**PUBLIC INTEREST REVIEW FOR GROUND WATER APPLICATIONS**

SUBJECT: Application G- 17449  
Supersedes review of \_\_\_\_\_ Date of Review(s) \_\_\_\_\_

**A. GENERAL INFORMATION:** Applicant's Name: Oregon State Lands County: Deschutes

A1. Applicant(s) seek(s) 4.5 cfs from 2 well(s) in the Deschutes Basin,  
Hampton Valley subbasin Quad Map: West of Hampton

### G-17449: West of Hampton Quadrangle

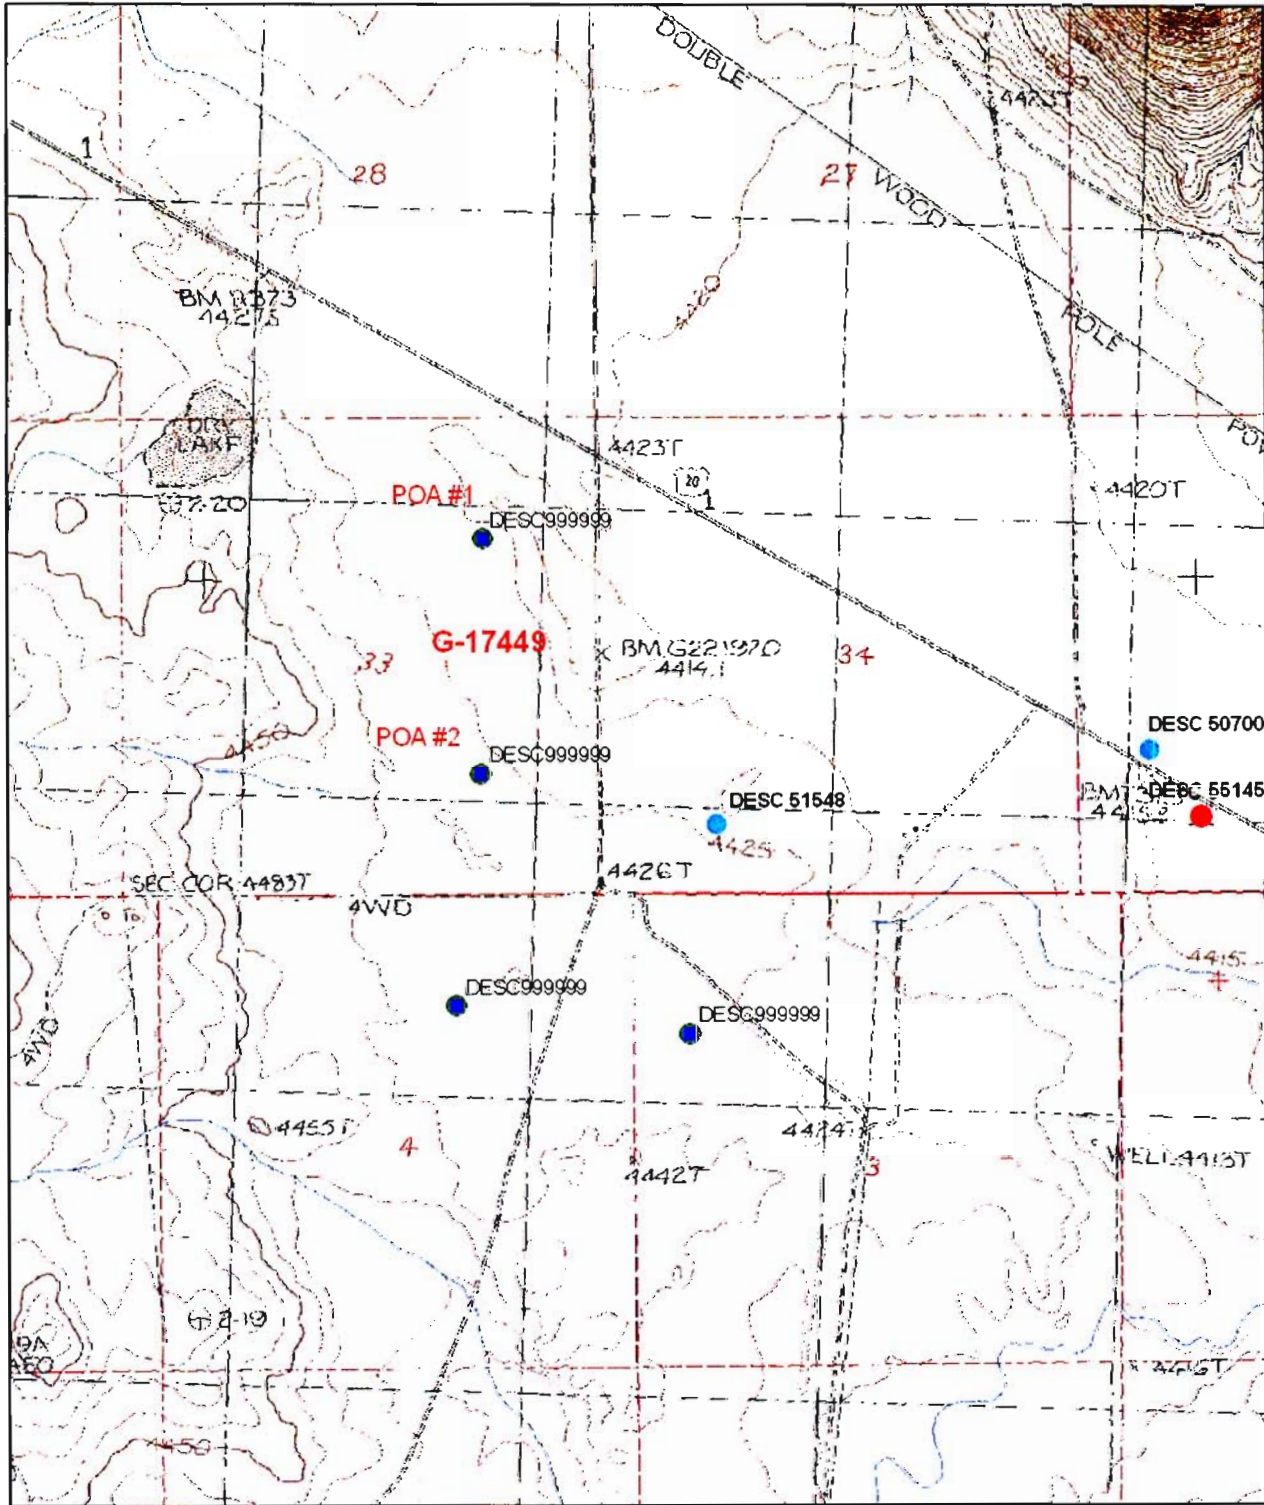
A4. **Comments: WELLS WILL BE CONSTRUCTED INTO SEDIMENTARY AND VOLCANIC DEPOSITS WITHIN A SMALL BASIN ALONG THE BROTHERS FAULT ZONE. GROUND WATER LEVELS ARE BELOW SPRINGS AND EPHEMERAL STREAMS IN THE AREA. GROUND WATER FLOW DIRECTION IS UNCERTAIN, BUT MAY BE TOWARDS THE NORTHWEST (MILLICAN VALLEY).**

C6. **SW / GW Remarks and Conditions** GROUND WATER FLOW DIRECTION IS UNCERTAIN, BUT MAY BE TOWARDS THE NORTHWEST (MILLICAN VALLEY). INTERFERENCE WITH THE NEAREST STREAM (CAMP CREEK) IS HIGHLY UNLIKELY GIVEN THE HYDRAULIC HEAD RELATION AND THE NEARBY OCCURRANCE OF EARLY TO MIDDLE TERTIARY GEOLOGIC UNITS THAT ARE TYPICALLY CHARACTERIZED AS BOUNDARIES TO REGIONAL GROUND WATER FLOW.

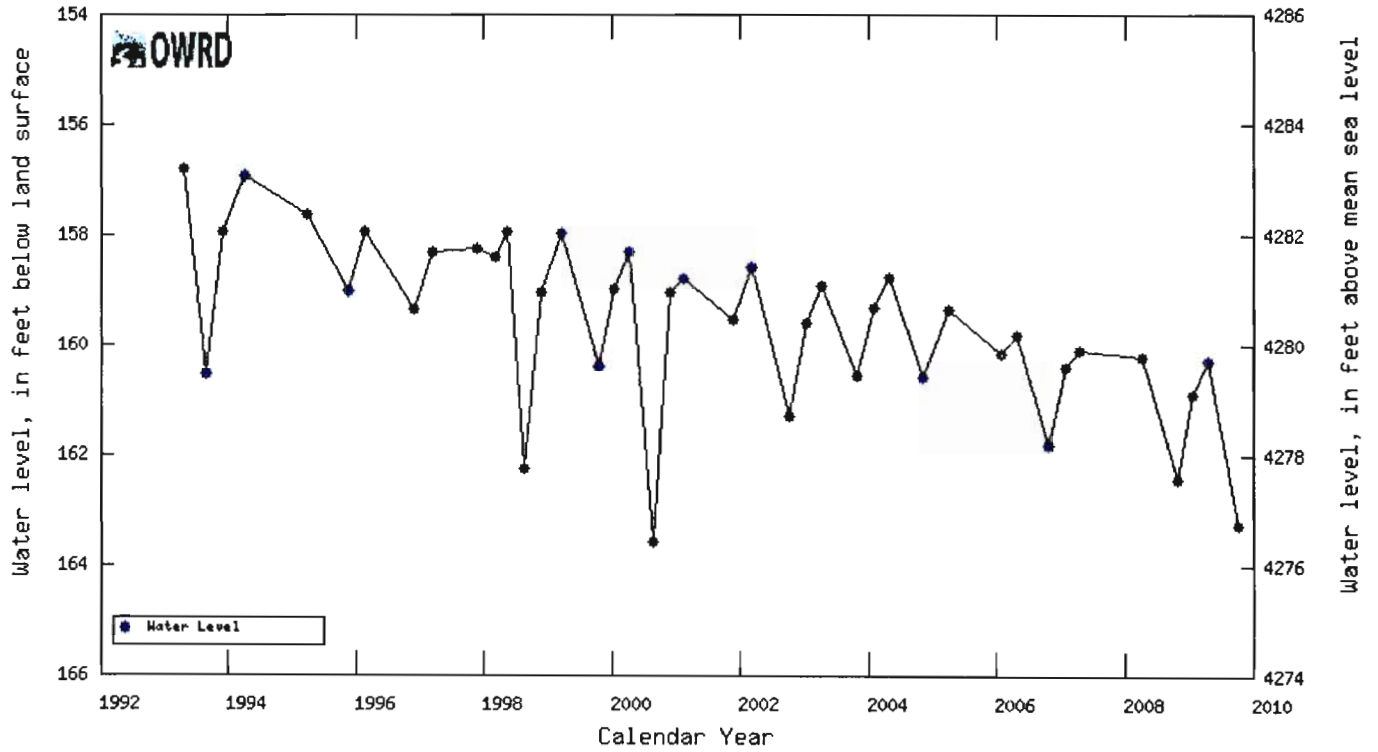
B3. Ground water availability remarks: SEVERAL HIGH YIELDING (1800 – 2600 GPM) WELLS ARE LOCATED OR PLANNED IN THE VICINITY OF THE WELLS ON THIS APPLICATION. TWO NEARBY WELLS HAVE RELATIVELY LONG-TERM MEASUREMENT RECORDS. DESC 53516 HAS BEEN MEASURED SINCE 1993 AND SHOWS A SLIGHT, STEADY DECLINE (3.5 FEET) OVER THE PERIOD OD RECORD. ANOTHER NEARBY WELL DESC 55145 HAS A SIMILAR TREND AND HAS DECLINED ABOUT 2.5 FEET SINCE 2004.
